North Eastern Regional Power Committee

**Sub: 84वीं संरक्षण समन्वय उप-समिति (पीसीसी) बैठक का कार्यवृत्त/ Minutes of 84<sup>th</sup> Protection Coordination Sub-Committee (PCC) Meeting**

### **84<sup>th</sup> Protection Coordination Sub-Committee Meeting**

**Date:** 09/10/2025 (Thursday)

**C.6 (Agenda B8, 82nd PCC) Frequent tripping of 132 kV Sanis-Wokha Line during July'25:**

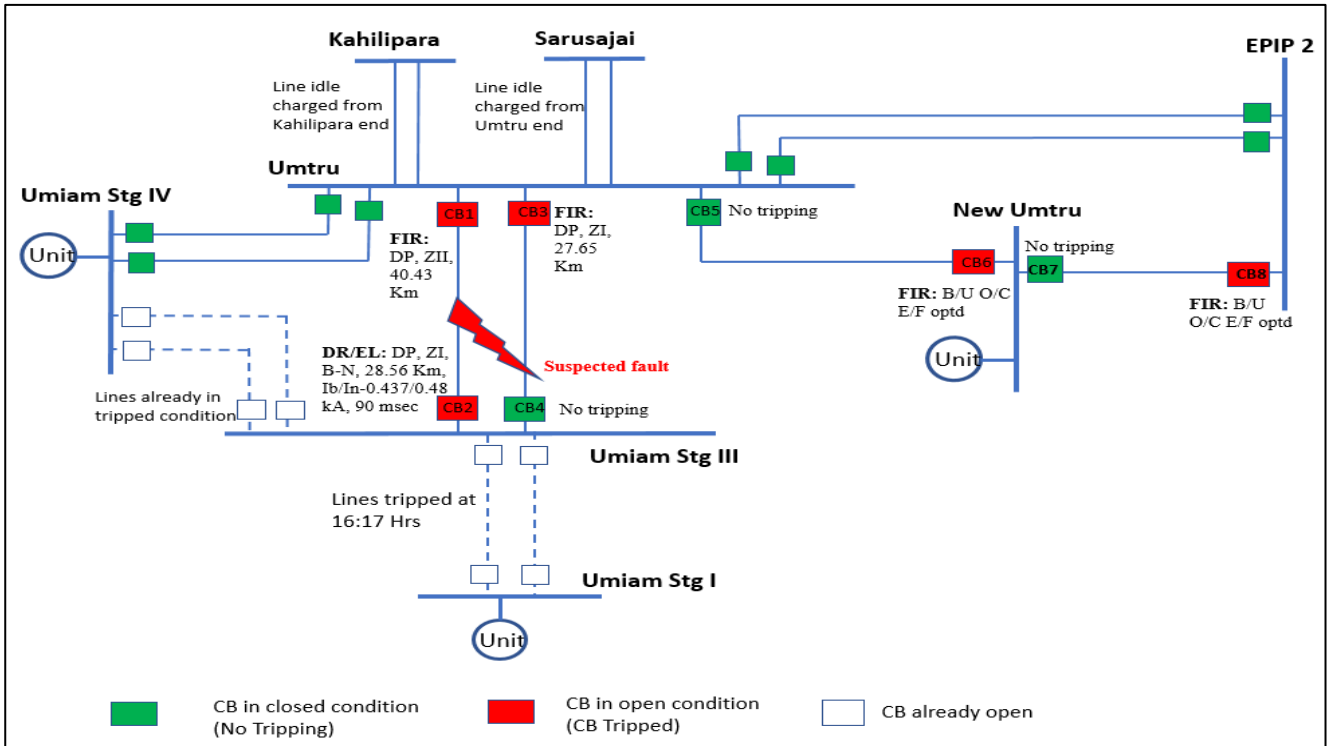
In 82nd PCCM, forum noted that most of the tripping were spurious in nature and some tripping may be due to settings issue. Forum urged DoP, Nagaland to analyze the root cause of such trippings and provide a report to NERPC and NERLDC.

### **C.8 (Agenda B11, 81st PCC) Grid Disturbance in Dharmanagar area of Tripura Power System and Dullavchera area of Assam Power System on 10th June'25:**

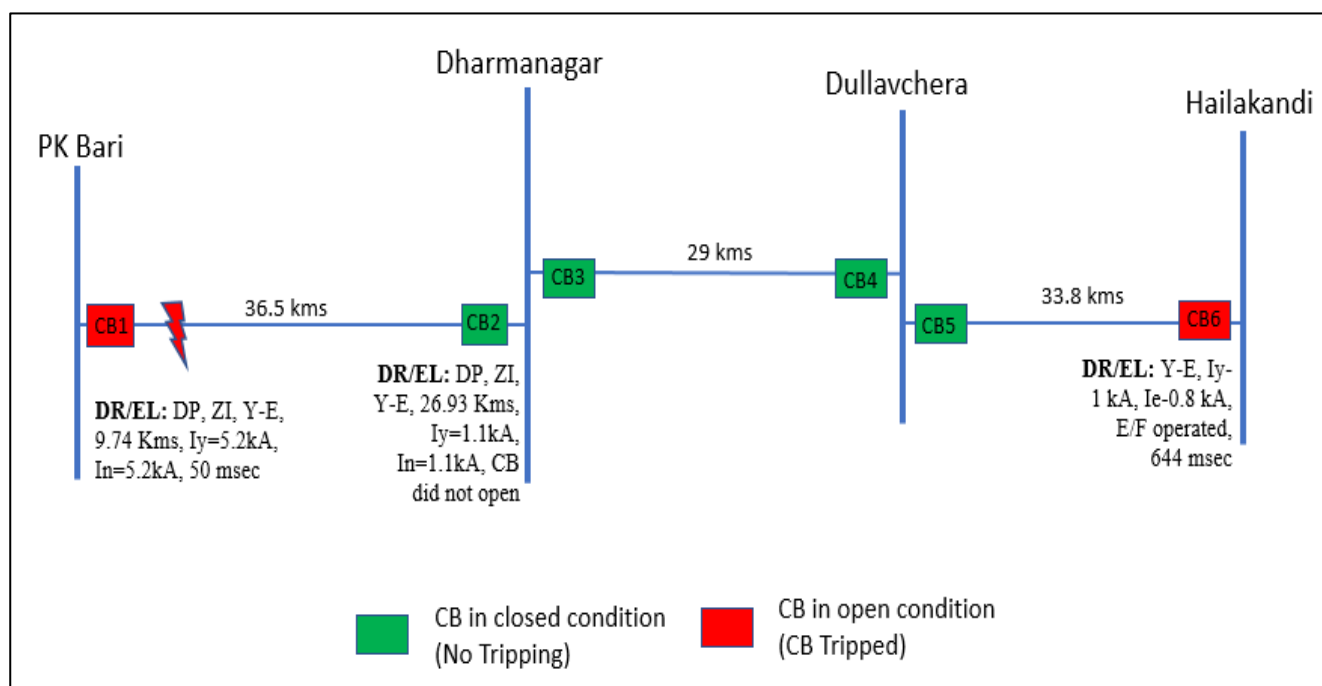
As per DR analysis, Y-N fault (Ib-5.2 kA, In-5.2 kA) initiated at 18:40:57.118 Hrs which was cleared within 50 msec from PK Bari on operation of DP, ZI. At Dharmanagar end, ZI trip command issued at 18:25:30.360 Hrs. However, CB did not open at Dharmanagar due to which fault was continuously feeding from Dullavchhera & Hailakandi end. Fault cleared by tripping of healthy 132 kV Hailakandi-Dullavchhera line within 644 msec from Hailakandi end on operation of E/F (DT send).

MS NERPC instructed the concerned utilities to provide updates to NERPC through email.

#### Event 1:

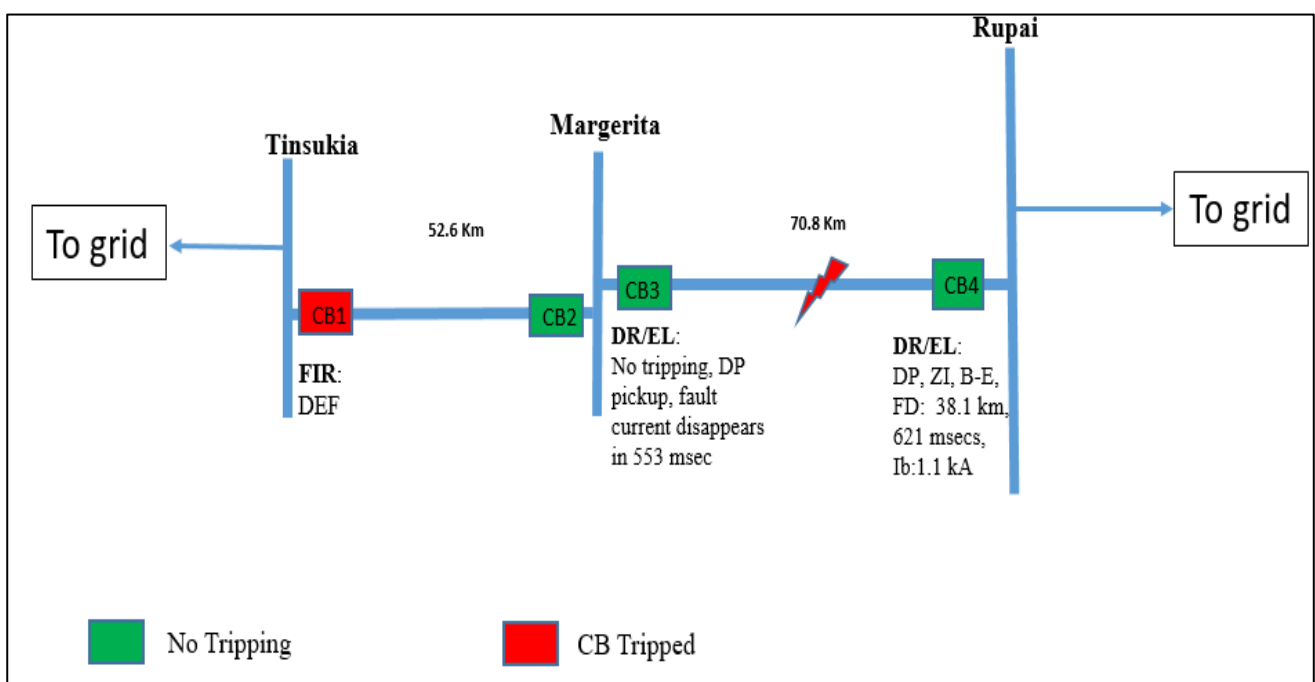
As per DR analysis, at 10:50:26.946 Hrs, high resistive B-E fault (Ib-1.1 kA, Vbe-51 kV) appears in 132 kV Rupai-Margherita line at a distance of 38.1 Km which was cleared from Rupai end within 621 msec on operation of DP, ZI. No tripping observed at Margherita end (DP pickup, fault current disappears within 553 msec).

- Time drift of 3 min observed at Rupai end for 132 kV Margherita Line.

### Event 2:

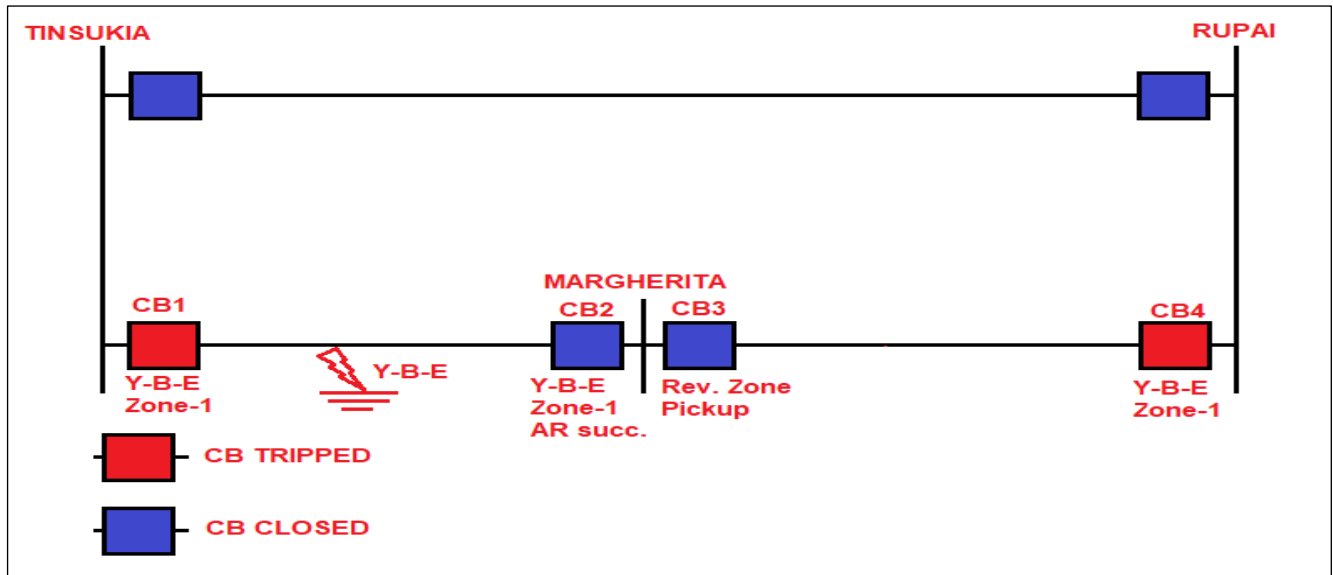
As per DR analysis, Y-B-E fault in 132 kV Tinsukia – Margherita line cleared from Tinsukia and Margherita end in 90 msecs on operation of DP, ZI. Margherita end (CB2) successfully auto-reclosed.

**Event 2:** Forum noted that zone 1 at Rupai for 132 kV Margherita line is overreaching and requested AEGCL to revise the reach of Zone1 protection. AEGCL informed S/D will be taken for testing of relay.

**C.10 (Agenda B15, 81st PCC) Grid Disturbance in Leshka, Mynkre, Mustem and IIM areas of Meghalaya Power System on 19th June'25:**

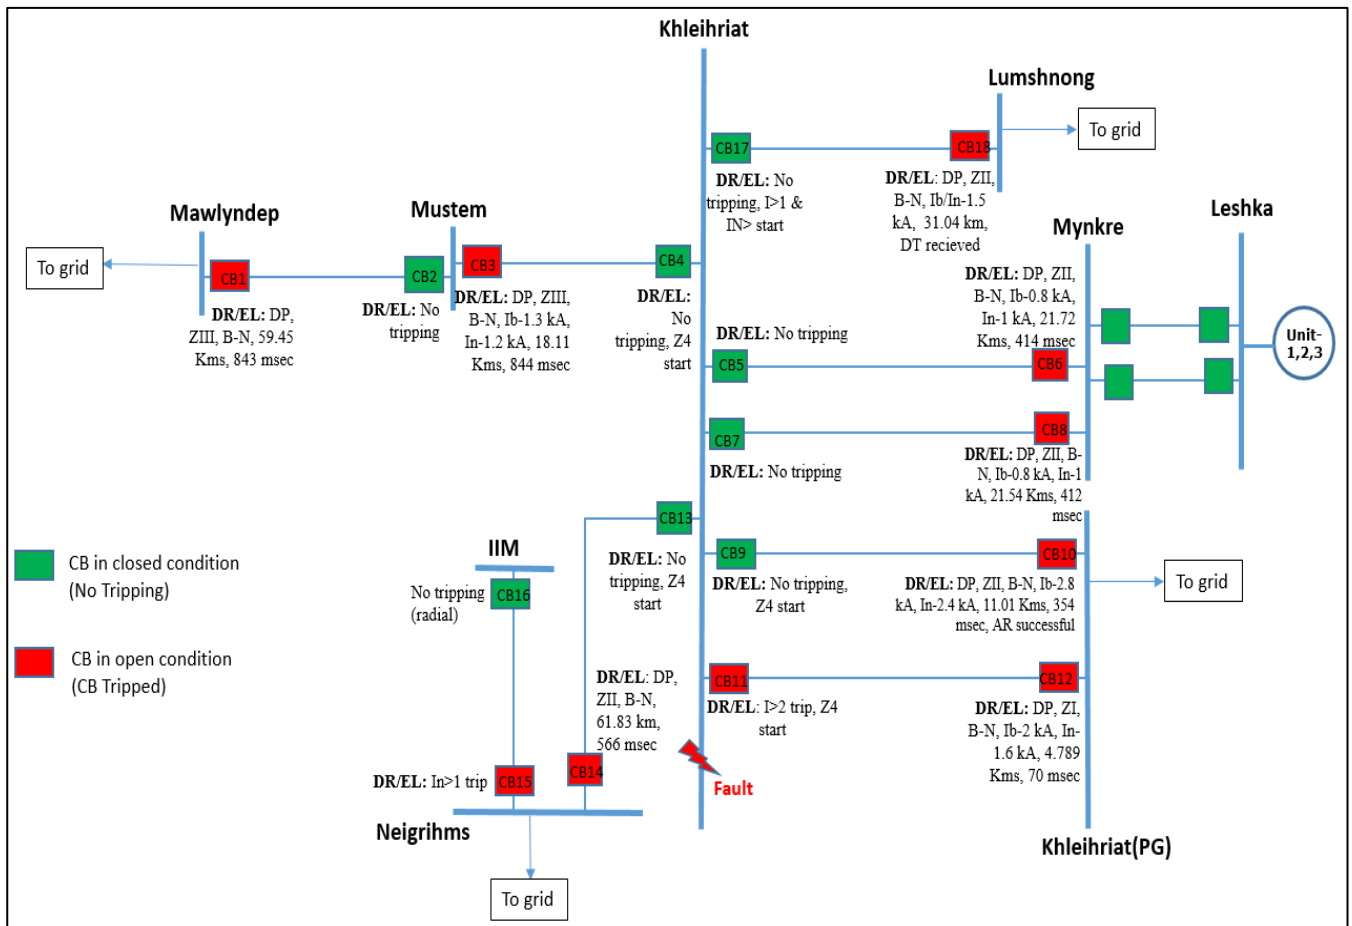
- Tripping of 132 kV Mustem-Khleihriat line on Z3 from Mustem end is inferred unwanted. Z3 reach setting needs to be reviewed and revised as per NER protection philosophy.

2	132 kV Khleihriat-Khleihriat(PG) II line tripped on I>2 from Khl(ME) end	Highset O/C setting to be disabled at Khl(ME)
3	AR operated successfully at Khleihriat(PG) end for 132 kV Khleihriat-Khleihriat(PG) I Line	AR successful due to incorrect mapping which has been rectified.
4	Tripping of 132 kV Mustem-Khleihriat line on Z3 from Mustem end	LFL of the feeder was carried out to ascertain the exact line length and line length indicated was 16.9 Km. Earlier setting was kept as per 12.69 Km. The setting of 132 kV Mustem-Khleihriat line has been revised as per new line length of 16.9 Km on 25th June'25.
5	DT received at Lumshnong end for 132 kV Khleihriat Line	To be checked by MePTCL
6	Tripping of 132 kV Neigrihms-IIM line on E/F from Neigrihms end for fault in reverse direction is unwanted	Rectified
7	Tripping of Umiam Stg-II Unit-2 for fault in 132 kV Khleihriat Bus	GT O/C protection operated. To be checked by MePGCL
